Westinghouse  
Electric Corporation

NTD-NRC-94-4276  
DCP/NRC0195  
Docket No.: STN-52-003

SUBJECT: WESTINGHOUSE RESPONSES TO NRC REQUESTS FOR ADDITIONAL  
INFORMATION ON THE AP600

NTD-NRC-94-4276  
ATTACHMENT A  
AP600 RAI RESPONSES  
SUBMITTED AUGUST 26, 1994

Figure 230.41-1  
Foundation of the Seismic Analysis Model  
for The Nuclear Island, Elevation 82'-6"

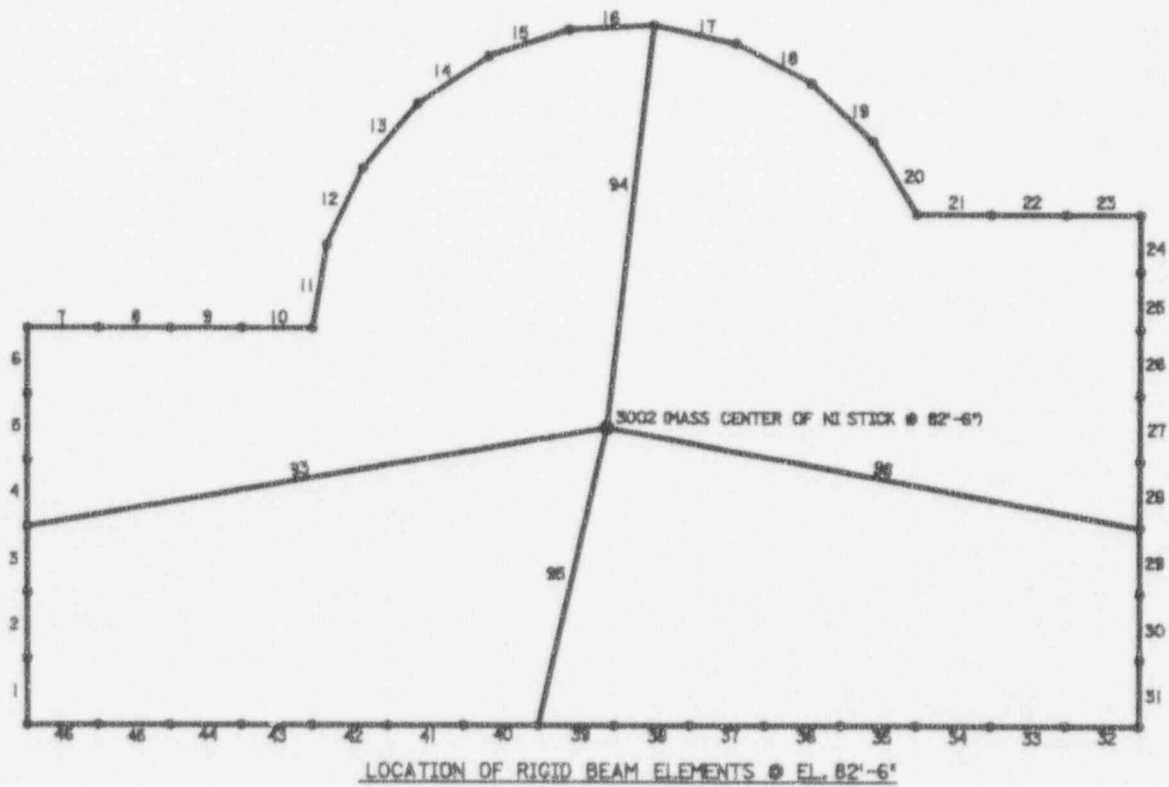
#### Question 230.41

#### Response: (Revision 1)

Figure 230.42-1  
2D SASSI Analysis, N-S Direction  
Lower Bound Soft Soil Profile

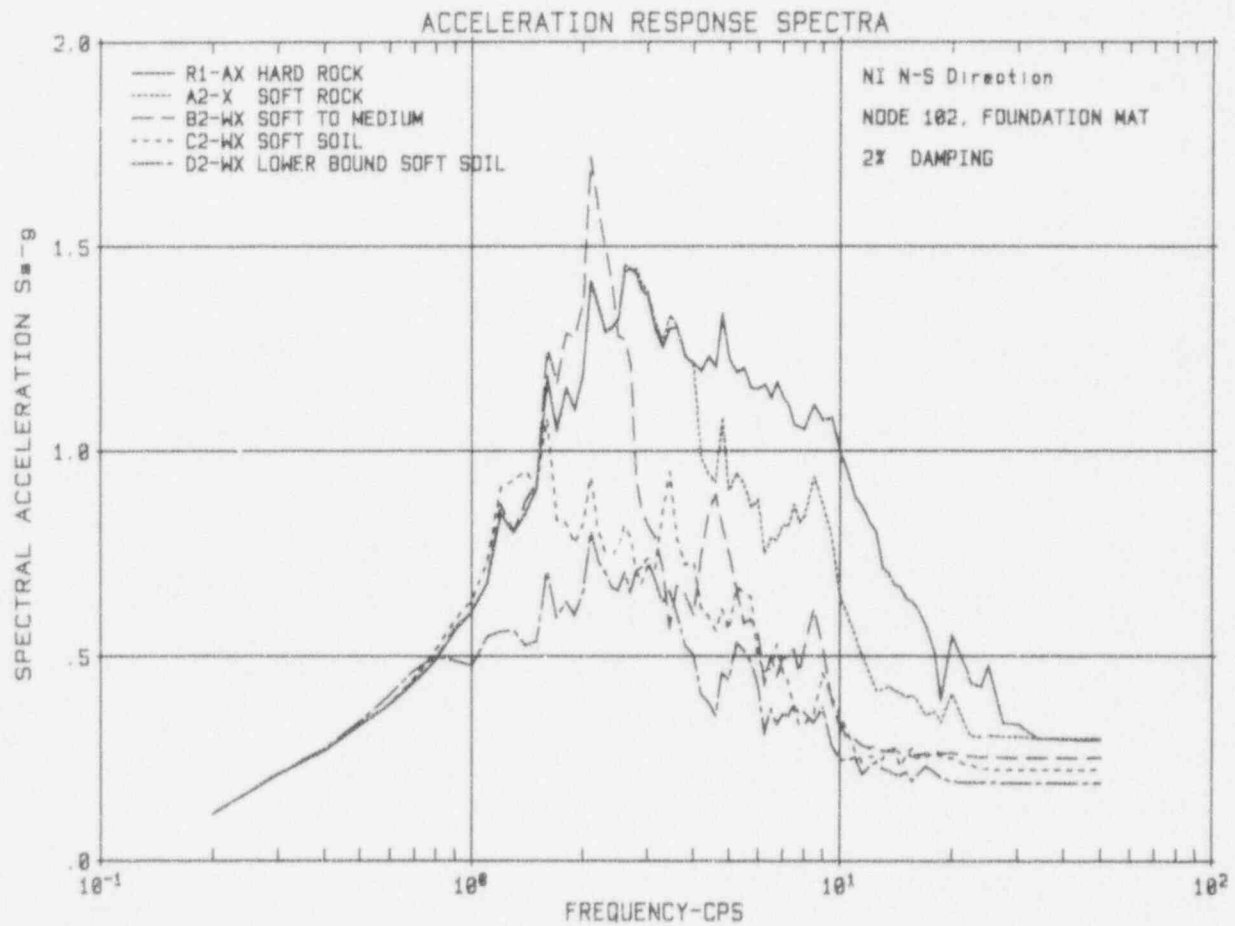
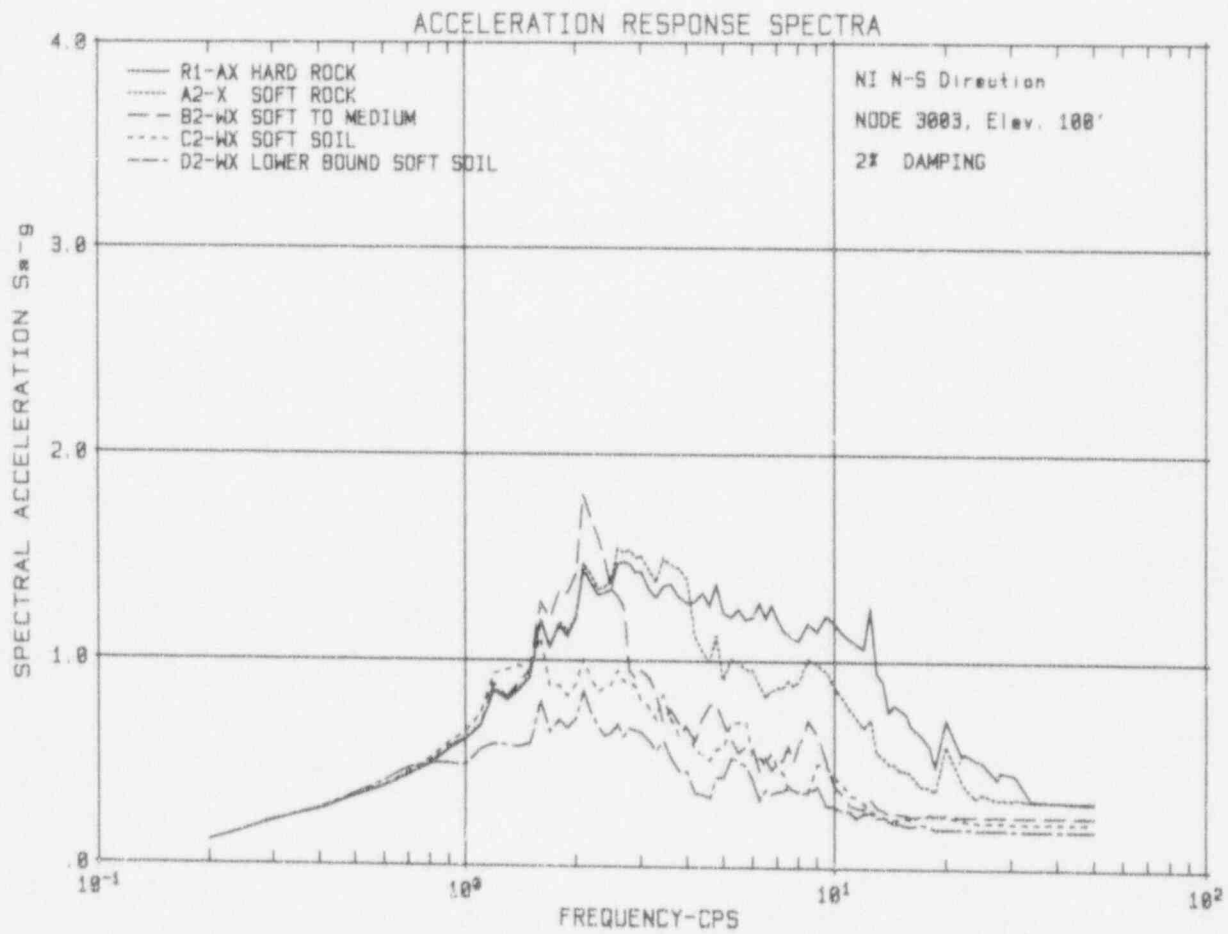
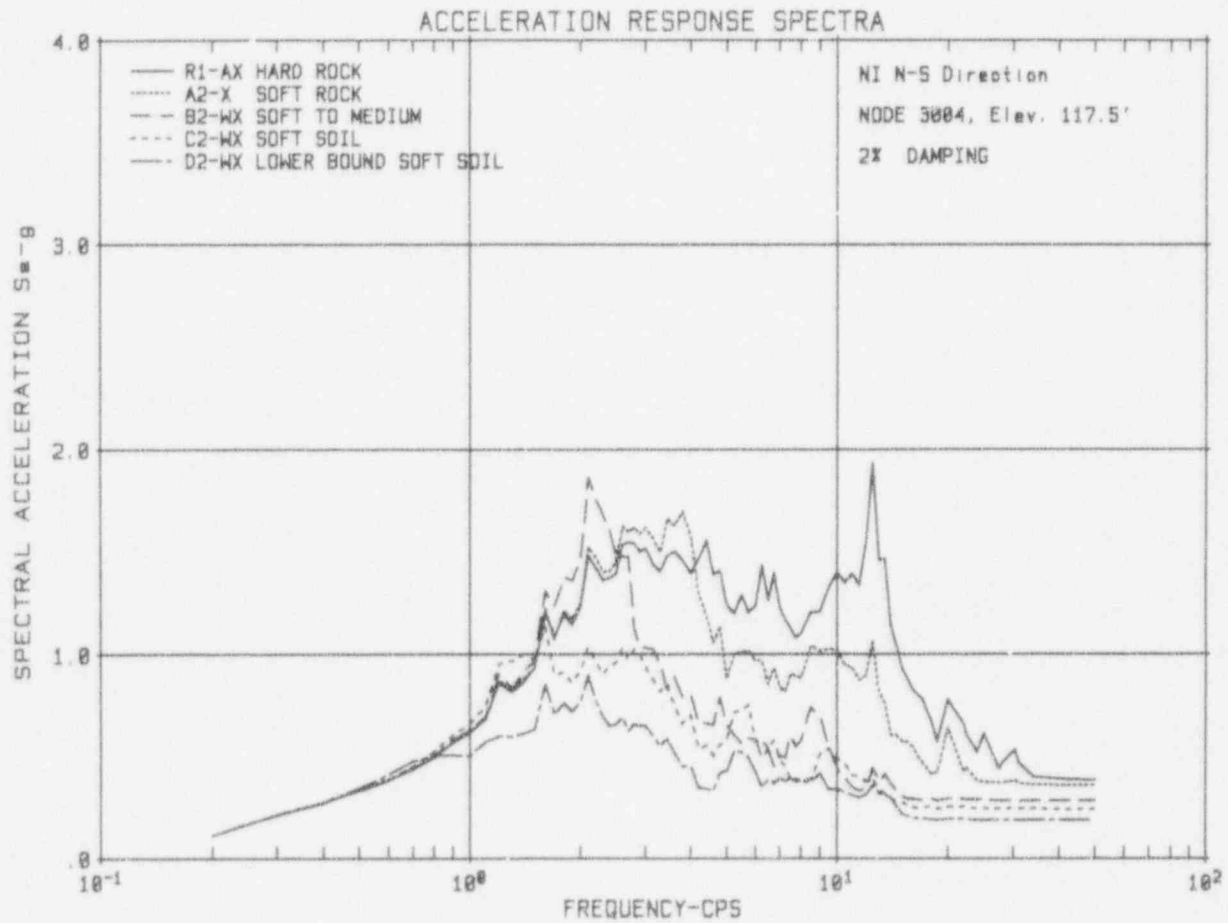
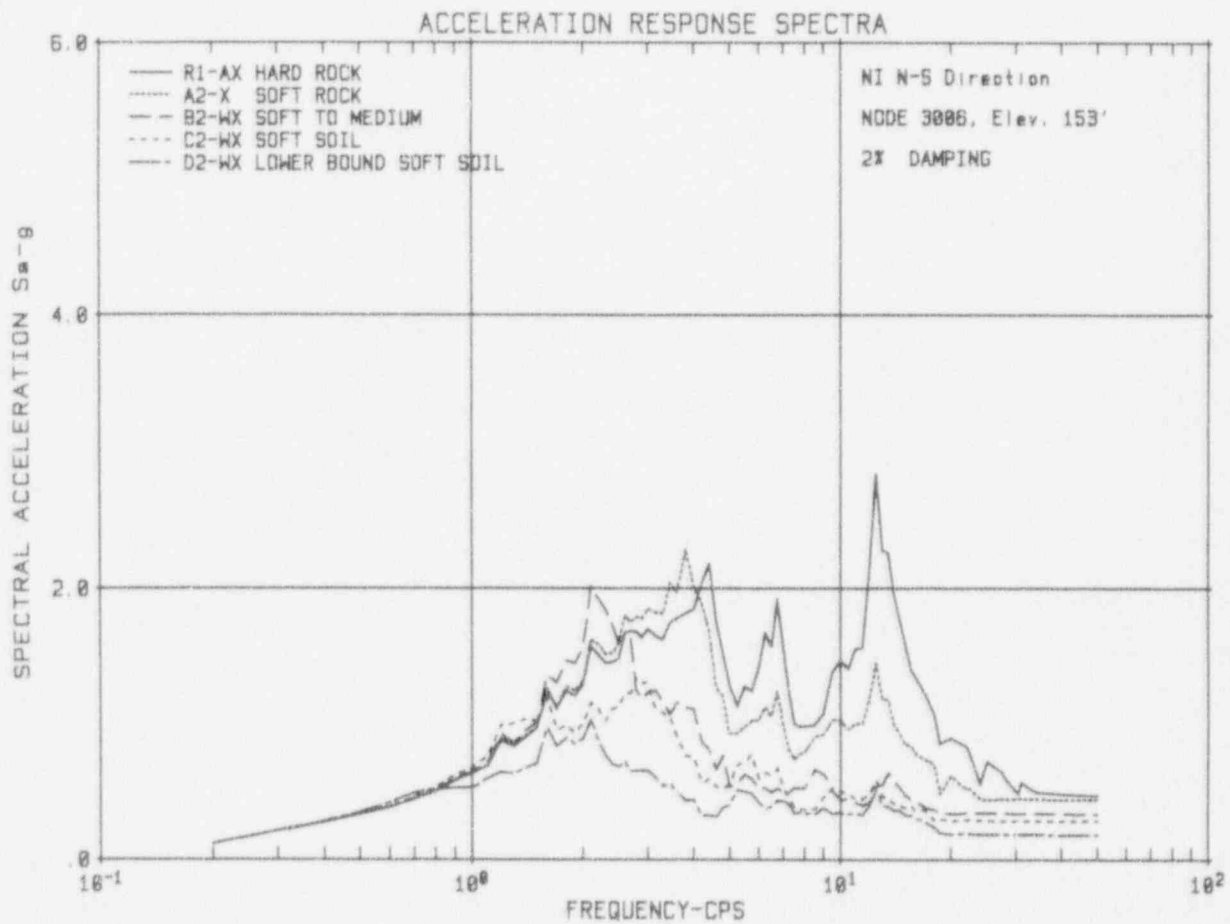
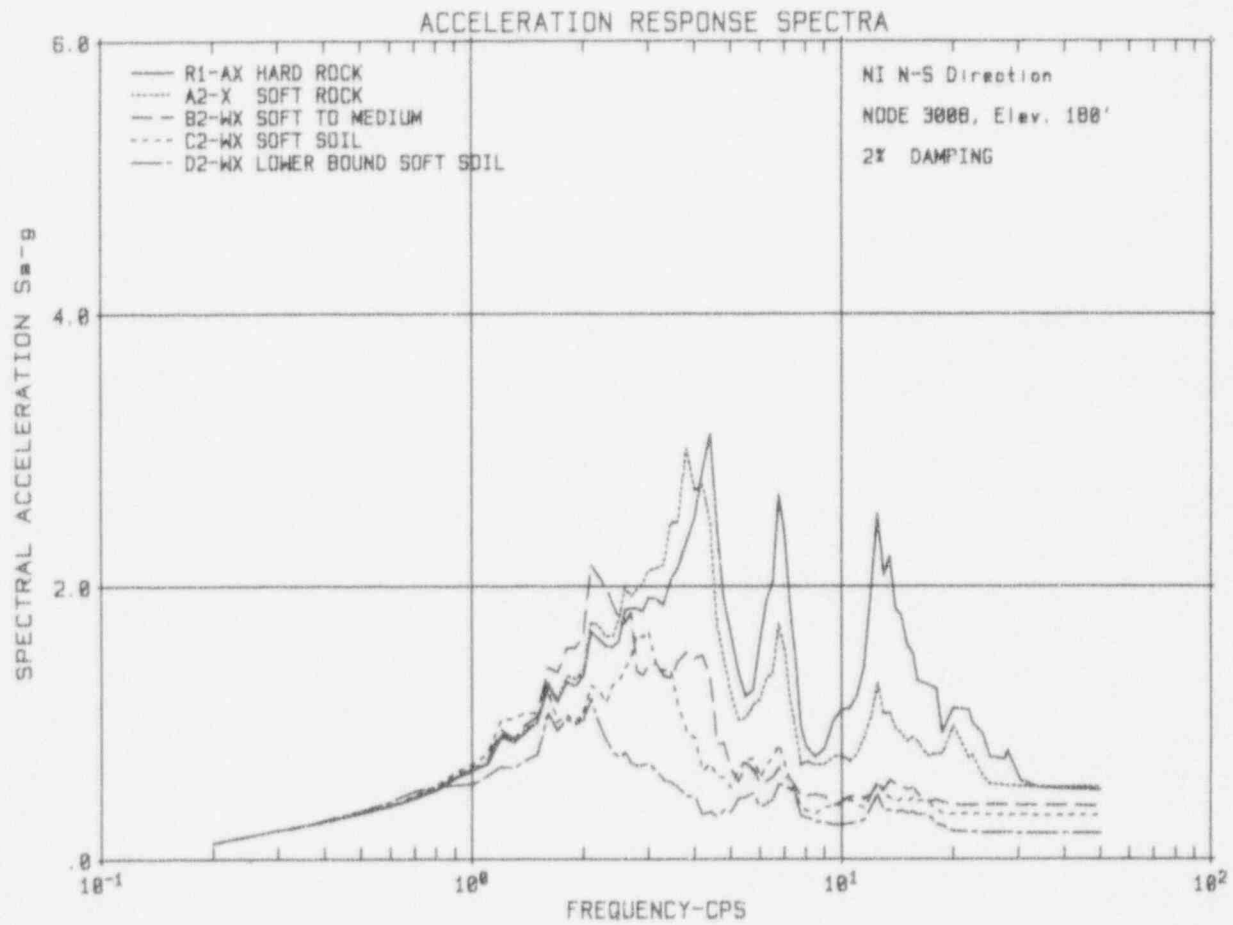
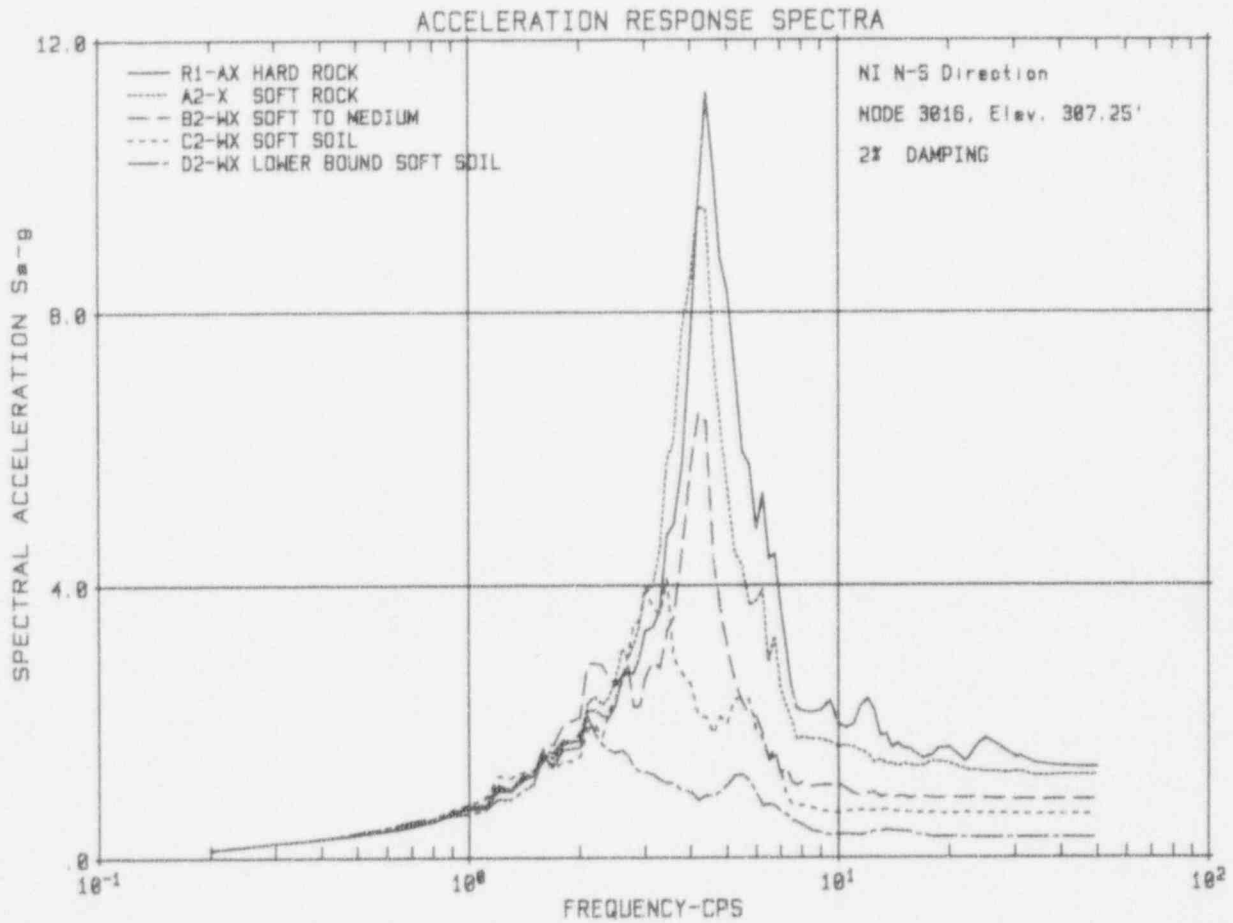
- a. The first paragraph of Section 3.7.2.4 states that the nuclear island SSI responses generated for the analysis and design of seismic subsystems include nodal displacements, nodal accelerations and floor response spectra (FRS). Explain how the structural member forces (forces and moments) used for the structural design were generated for a soil site condition.

- b. The soft soil profiles considered in the SSI analysis (see Figure 2A-7 of the SSAR, Appendix 2A) has a linear shear wave velocity profile varying from 1000 ft/sec at the ground surface to 1200 ft/sec at 240 ft depth. This profile is considered the minimum "best estimate" velocity profile among the soil cases. In order to study the effect of lower bound shear wave velocities associated with the variation in the "best estimate" profile, a reduction of 50 percent in the low-strain shear modulus was analyzed. The resultant shear wave velocity for the lower bound case has a low-strain velocity of 707 ft/sec at the ground surface increasing to 850 ft/sec at 240 ft depth. This profile was analyzed using SHAKE and the Idriss 1990 soil curves (see response to RAI 230.79). The resultant strain-compatible soil properties were used in the 2D SSI analysis in the NS direction considering the depth to base rock of 120 ft and the water table at grade level. The SSI results of this case (marked as the lower bound soft soil case) are compared with the SSI results of the minimum "best estimate" profile (marked as the soft soil case) and with those of other design profiles (hard rock, soft rock, soft-to-medium soil) in Figures 230.42-1 through 230.42-11. As shown in these figures, the results of the lower bound soft soil case are enveloped by the results of other SSI cases except for small exceedences at very low frequencies (less than 1 Hertz) with no significant effect on the design responses. Based on these results, the soft soil profile (1000 ft/sec at the surface to 1200 ft/sec at 240 depth) is considered to be the minimum "best estimate" profile in the site interface conditions.
